WATER QUALITY MEMORANDUM

Utah Coal Regulatory Program

RE: Fourth Quarter 2017 Water Monitoring, Bowtie Resource Materials, Fossil Rock Mine, C/015/0009, Task ID #5638

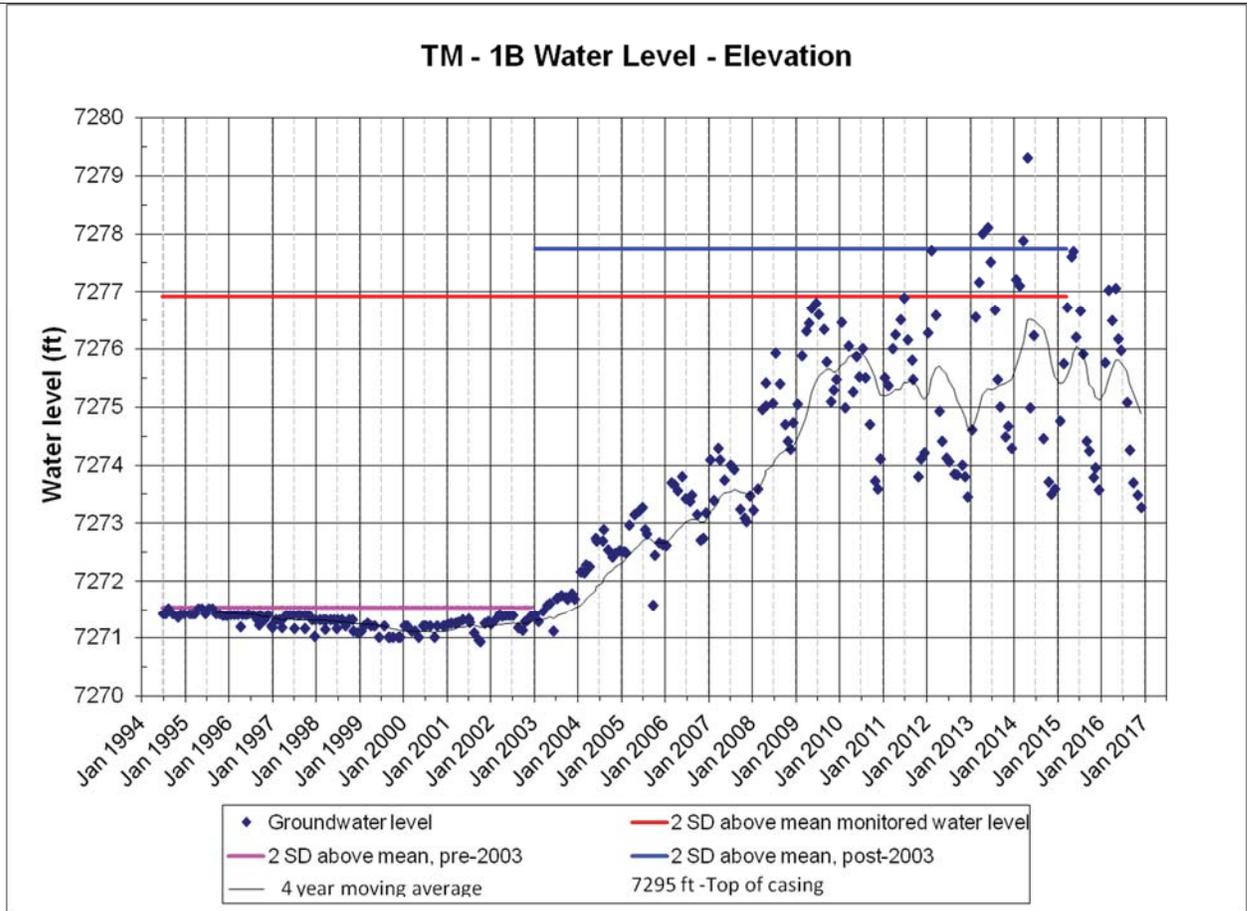
Figure 1. The water level in TM-1B has been rising since mine dewatering ceased in May 2001. It's difficult to say where the water level will come to rest. The well is completed in the Panther tongue of the Star Point sandstone below the mine workings. This sandstone tongue contacts the floor of the mine workings. Mine dewatering reduced the potentiometric head within the unit and the mine pool is probably recharging the unit. This graph will be updated when mining begins in the Cottonwood Track.

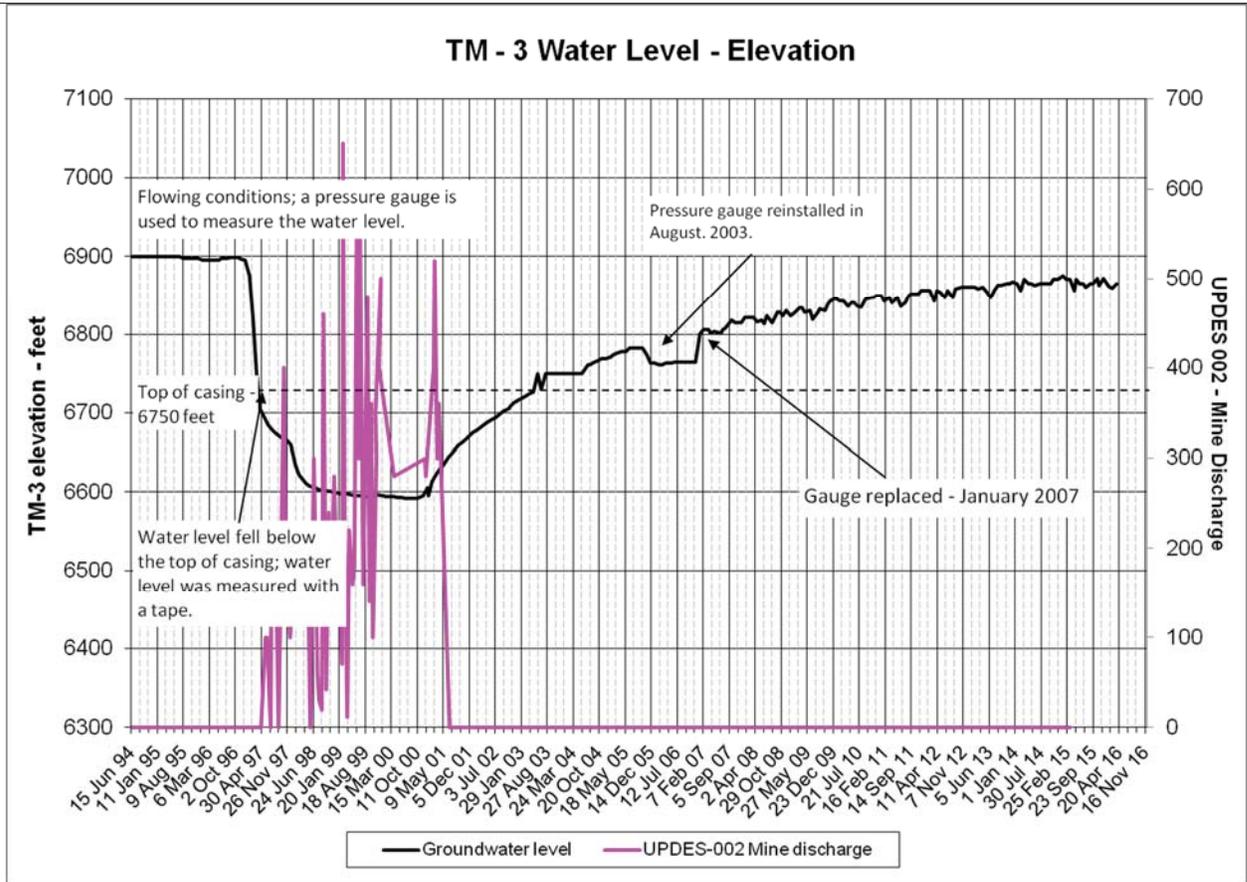
Figure 2. TM-3 water elevation peaked in June 2005, remained steady through October, dropped 18.5 ft in November and December 2005 and remained virtually unchanged during 2006. The pressure gauge was replaced in January 2007 and values jumped to approximately match the pre-2006 curve. During the first half of 2007 the curve was relatively flat, but it has been steadily climbing. The outgoing document [Reduce Hydrologic Monitoring Sites, PacifiCorp, Deer Creek, C/015/0018, Task ID #4332](#) stipulates this well should not be released until 6,900 ft is reached. This graph will be updated when mining begins in the Cottonwood Track.

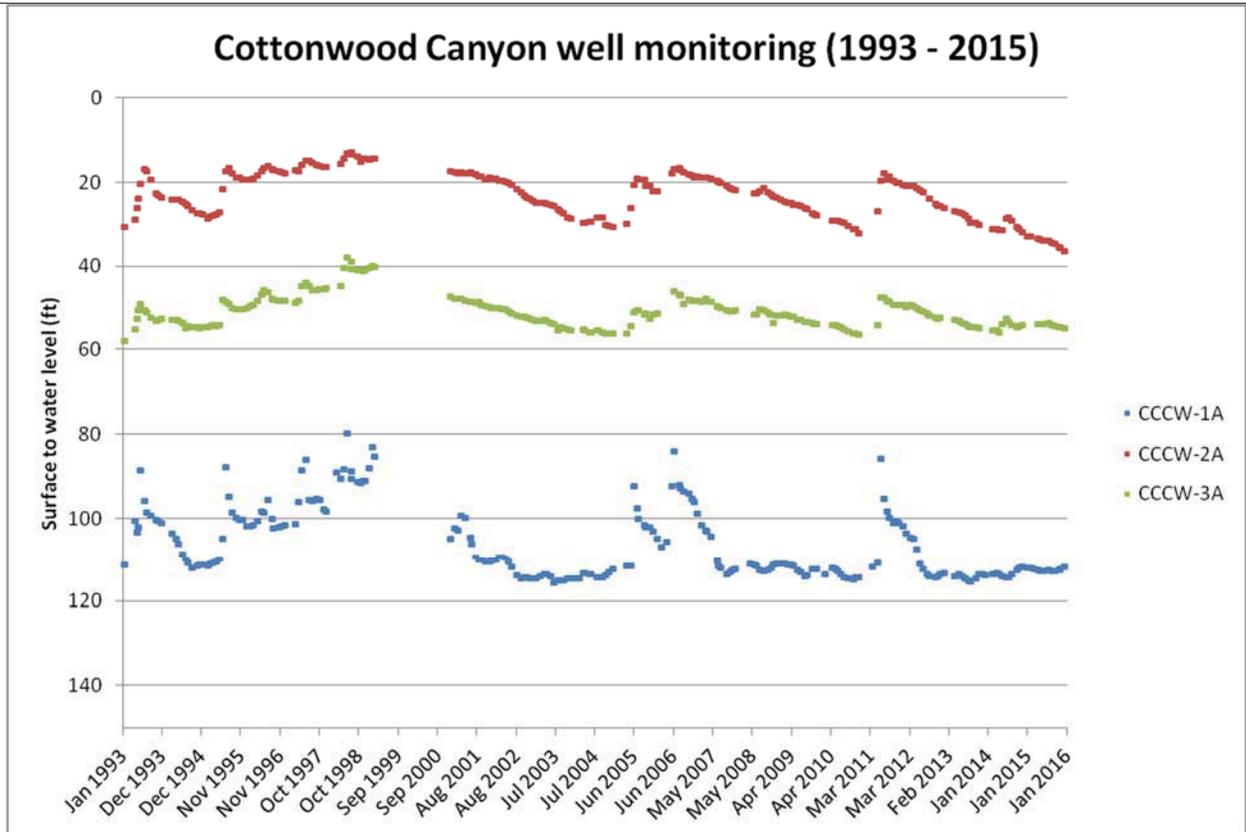
Figure 3. Alluvial aquifer water levels in the Cottonwood Canyon Creek monitoring wells. The drill hole data is found in Trail Mountain MRP Appendix C p. 23. This graph will be updated when mining begins in the Cottonwood Track. At this time the wells are primarily responding to climatic variability.
